Agenda
Lane Cove Local Planning Panel Meeting
16 August 2022,

Lane Cove Local Planning Panel Meeting 16 August 2022
138 RIVERVIEW STREET, RIVERVIEW.

Subject: 138 Riverview Street, Riverview.
Record No: DA22/5-01 - 41168/22
Division: Environmental Services Division
Author(s): Andrew Bland

**Lane Cove Local Planning Panel Meeting 16 August 2022
39 VISTA STREET, GREENWICH.**

Figure 4: Northern elevation (Source: Architectural plans)

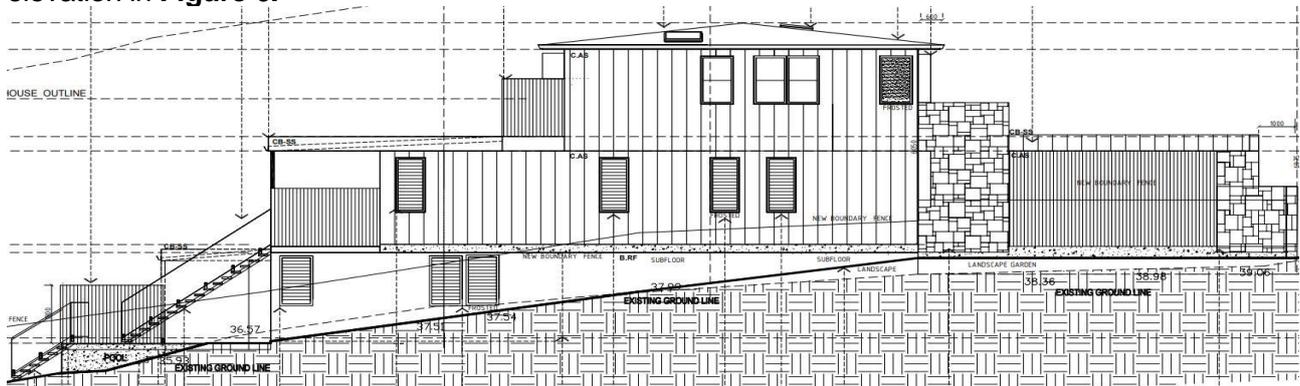
The Development Application is for the demolition of the existing structures and the construction of a two storey dwelling house, a double garage, a swimming pool and related landscaping. The northern side elevation can be seen in **Figure 4**, the western rear elevation in **Figure 5** and the eastern front elevation in **Figure 6**.

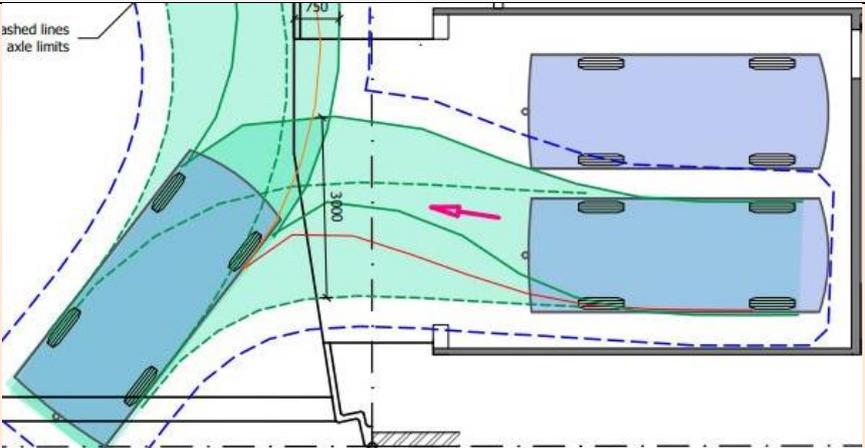
i. Wall height – Part C1.7.1(a) stipulates a maximum wall height of 7.0m where a wall height of 8.2m is proposed. The applicant has sought to justify the variation on the grounds that the site is steeply sloping and that the overall height of the building is well within the height controls. A variation is considered reasonable in this instance as the proposal is well within the allowable 9.5m height control, the solar access provisions have been achieved and the wall height non-compliance is accentuated by the required subfloor (see next section).

ii. Subfloor height – Part C1.7.1(b) stipulates a maximum subfloor height of 1m where a subfloor of up to 1.7m is proposed. The applicant has sought to justify the variation on the grounds that Council requested a reduction in the proposed excavation within the request for further information amendments. A variation is considered reasonable in this instance as the proposal is well within the allowable 9.5m height control, the limited excavation (through the utilisation of a subfloor) addresses Council's concerns and there would be minimal impacts on the amenity of adjoining properties.

Figure 15: View loss corridors (Source: Google maps)

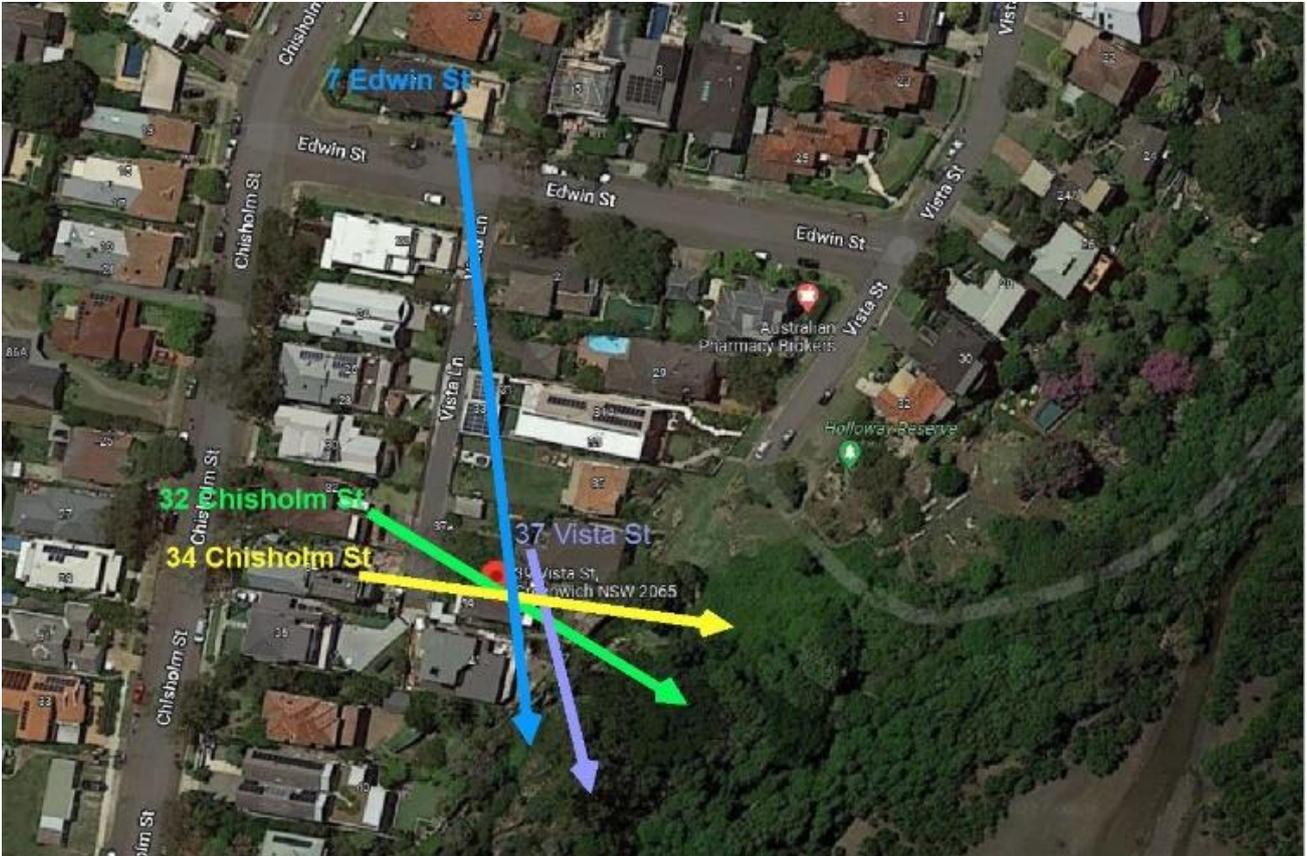
The proposed development impacts the views of multiple properties as shown in **Figure 15** below. A tenacity principle assessment for the individual properties follows. **All images were sourced by the Lane Cove Town Planner**
